Design Review Board Agenda

| A. PL2015-0028 Mill Park Vista Building Elevations and Landscaping ⁽²⁾ | |

**CITY OF MILL CREEK
DESIGN REVIEW BOARD
APPLICATION PL2015-0028**

- NAME OF PROJECT:** Mill Creek Park Vista
- APPLICANT:** M2 Architects
1111 Cleveland Avenue, Suite 102
Mt. Vernon, Washington 98273
- LOCATION:** The project is located on the east side of 9th Avenue SE approximately 900 feet south of the intersection of 9th Avenue SE and 164th Street SE, Mill Creek, Washington
- PROPOSAL:** Building elevations, colors, and materials along with landscaping and lighting for a new business and industrial park complex.
- ZONING:** Business and Industrial Park

BUILDING "B" – NORTH ELEVATION
SCALE: 1/8" = 1'-0"

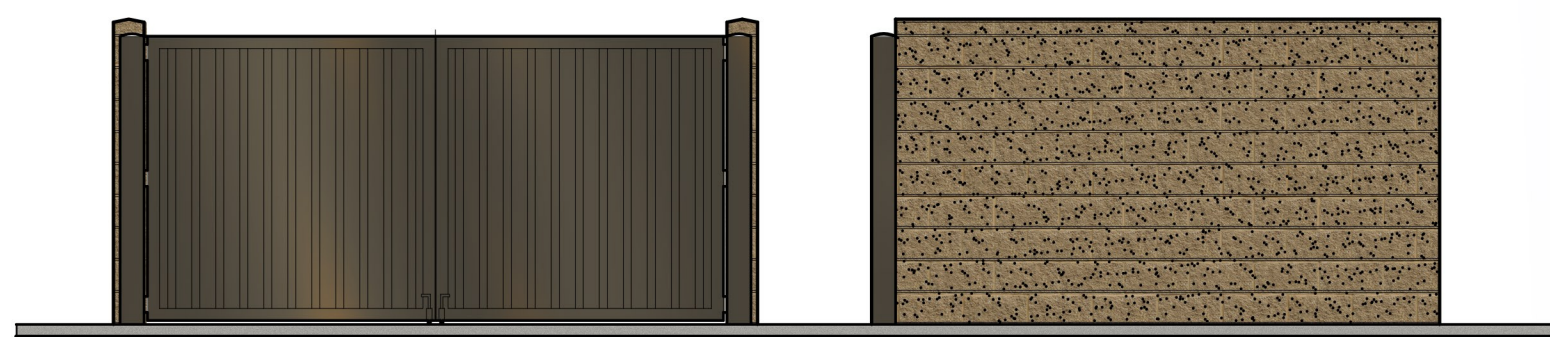
Building B has an equivalent level of detail for the east, west and south elevations. However, the north elevation, which is the warehouse entry with the large sectional metal garage doors to allow truck and material/product delivery, is visible from 9th Avenue SE and the access driveway, and lacks the detail and material variety that the other three elevations provide. The applicant is proposing only one material type, fiber cement lap siding. To break up the building façade and provide the same level of detail as proposed on the other three sides of the building, staff recommends as a Condition of Approval that stone veneer be installed on the lower three feet of the building to be consistent with the City’s design standards.

2. The design, colors and building materials shall be as portrayed on the application, except as revised in the conditions below.
3. On the north elevation of Building B, stone veneer is to be installed on the lower three feet of the building to break up the building façade and provide a consistent level of detail as is provided on the other three sides of the building.

BUILDING "C" – EAST ELEVATION
SCALE: 1/8" = 1'-0"

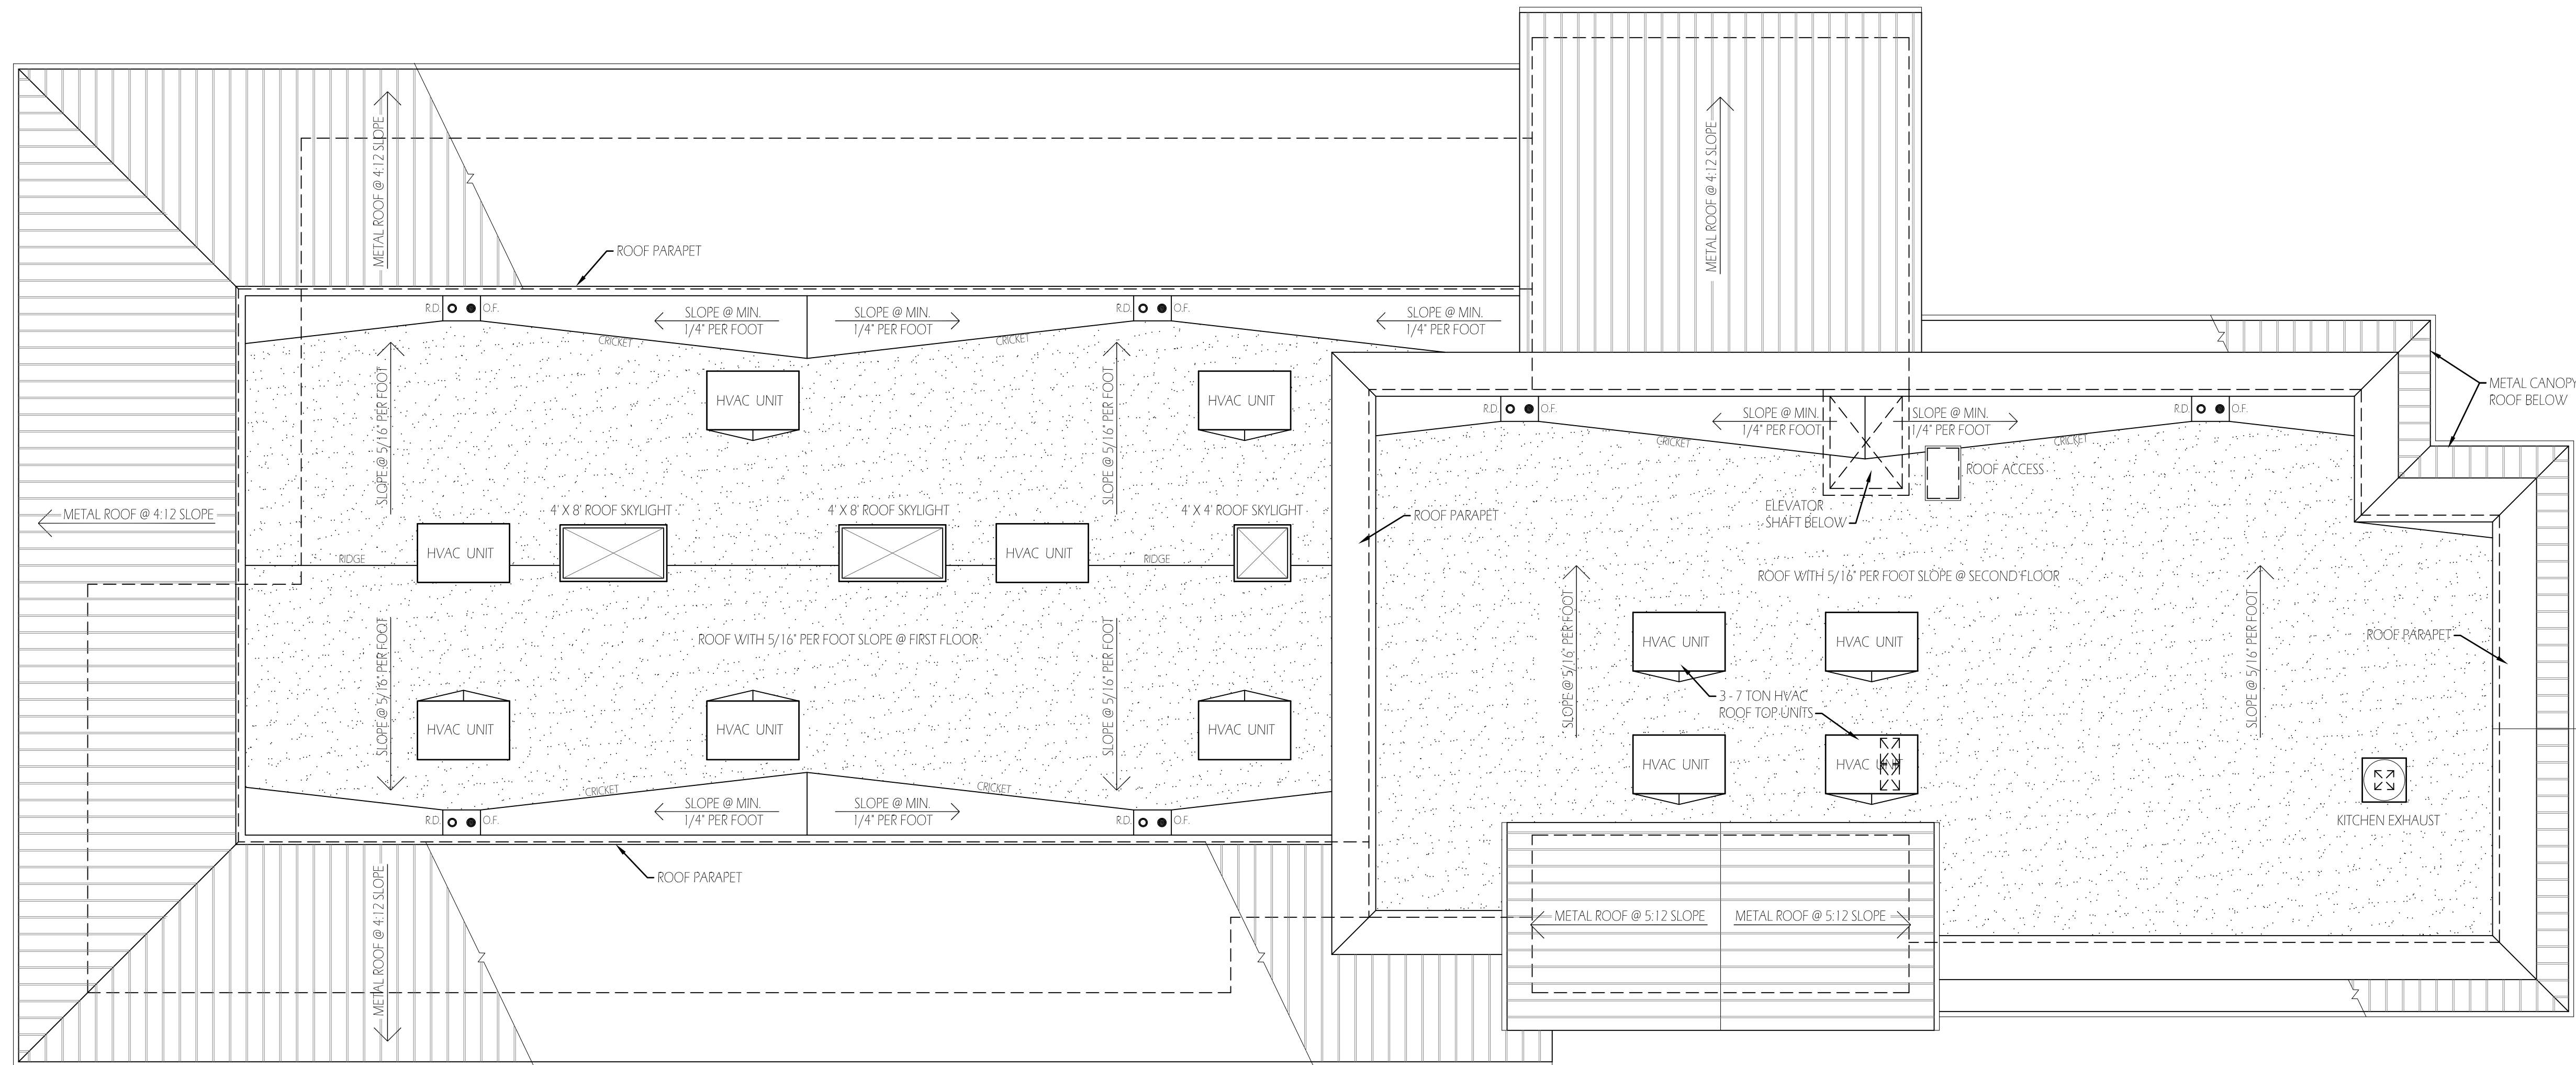
Building C has an equivalent level of detail on the north and west elevations. However, on the east elevation stone veneer is only proposed on the north end of this façade. To provide a consistent level of detail on all sides of the building, staff recommends as a Condition of Approval that on the east elevation stone veneer be consistently installed on the lower three feet of the building. Also, on the south elevation the applicant is proposing to use only one material type, the fiber cement lap siding. To break up the façade and provide an equivalent level of detail on all sides of the building staff recommends as Conditions of Approval that a fir trellis detail be installed above the two doors and over the two set of windows on the [west end](#), similar to what is proposed above the windows on the north elevation.

4. On the east elevation of Building C, install stone veneer consistently on the lower three feet of the building.
5. On the south elevation of Building C, add a fir trellis detail above the two doors and over the two sets of windows on the west end, similar to what is proposed above the windows on the north elevation.
6. The monument sign's dimension shall be revised to meet City Code which is a maximum of 42 inches high and 34 square feet (MCMC 17.26.020.E.6).
7. Substitute the Douglas Firs in the parking lot with another evergreen tree for that will be suitable for the parking lot environment and the long term growth constraints of the parking island.

ENTRY SIGN LOCATION
1/8" = 1'-0"

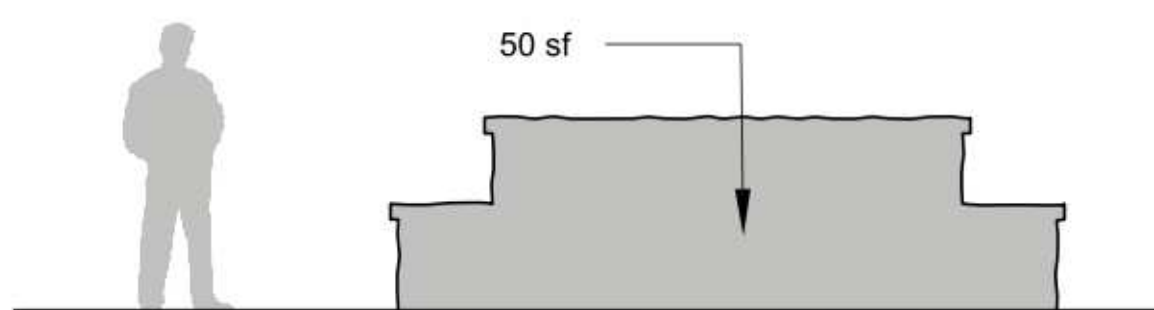
On the south side of the entry drive the applicant is proposing to install a 50 inch high and 50 square foot freestanding (monument) sign with a five foot from the right-of-way. The sign is proposed to be constructed of stone veneer on a concrete wall with backlit capital letters in "Rockwell-Bold" font constructed of dark bronze anodized aluminum. The applicant is proposing to limit the text to read "Mill Creek Park Vista" to identify the complex along with a logo with two trees. As proposed the sign height and size exceeds the City's allowed 42 inch high height limit and 34 square feet sign area maximum for business and industrial parks, MCMC 17.26.020.E.6. Therefore, as a Condition of Approval staff is requiring that the sign be reduced to a maximum of 42 inches high and 34 square feet in sign area. See *Attached Planting Plan Sheet L-2*.
